SUBJECT: MONTICELLO NUCLEAR GENERATING PLANT - INTERIM STAFF
EVALUATION RELATING TO OVERALL INTEGRATED PLAN IN RESPONSE
TO PHASE ONE OF ORDER EA-13-109 (SEVERE ACCIDENT CAPABLE
HARDENED VENTS) (TAC NO. MF4376)

INTERIM STAFF EVALUATION
BY THE OFFICE OF NUCLEAR REACTOR REGULATION
RELATED TO ORDER EA-13-109 PHASE 1 MODIFYING LICENSES
WITH REGARD TO RELIABLE HARDENED
CONTAINMENT VENTS CAPABLE OF OPERATION UNDER
SEVERE ACCIDENT CONDITIONS
NORTHERN STATES POWER COMPANY - MINNESOTA
MONTICELLO NUCLEAR GENERATING PLANT
DOCKET NO. 50-263

Figure 1 [of the OIP]: HCVS Exhaust Vent

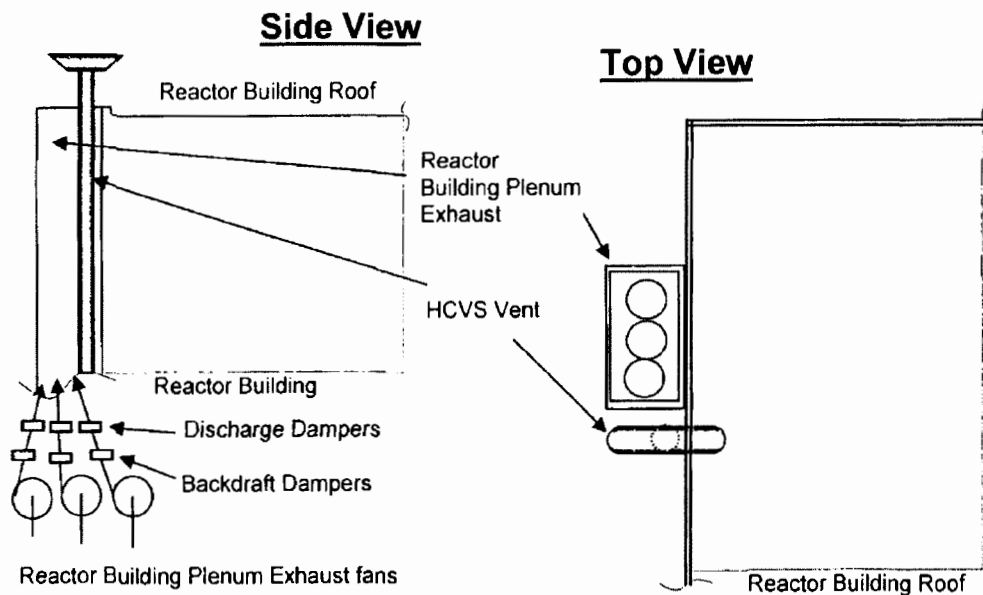
The HCVS discharge path is currently routed next to the Reactor Building plenum exhaust with the vent exhaust 3 ft. above the top of the Reactor Building plenum exhaust stack (see Figure 1 [of the OIP]). The vent exhaust is above the main plant structures. The vent is located greater than 100 ft. above ground level, providing an elevated release point that will not affect personnel staging any portable equipment needed for the Beyond Design Basis External Event (BDBEE).

The HCVS exhaust vent is not near the Reactor Building intake, control room intake, or the emergency response facilities, but is next to the Reactor Building plenum exhaust path. The Reactor Building plenum exhaust fans will be without a power source in a station blackout.

There are two dampers after each Reactor Building plenum exhaust fan - a backdraft damper and discharge damper. The discharge damper will close on loss of power associated with the station blackout and the backdraft damper will close on loss of Reactor Building exhaust flow. Both dampers are designed to prevent reverse flow, and therefore, prevent HCVS gases from entering the Reactor Building via the plenum room. Safety related dampers also isolate the plenum room from the rest of the Reactor Building. The "T" at the top of the vent will also be removed and replaced with a straight exit with a weather cap. This change will direct the vented gases upward and away from the plant.

As far as the HCVS effluent release point is concerned, the licensee identified an alternative to the effluent release point described in the guidance provided by NEI 13-02, Section 4.1.5.2.2.

The alternative considers and addresses the underlying provisions of Order EA-13-109, Sections 1.1.3 and 1.2.12 which state:

Therefore, MNGP's HCVS existing effluent release point location appears to be an acceptable alternative to the release point described in the guidance provided by NEI 13-02, Section 4.1.5.2.2.
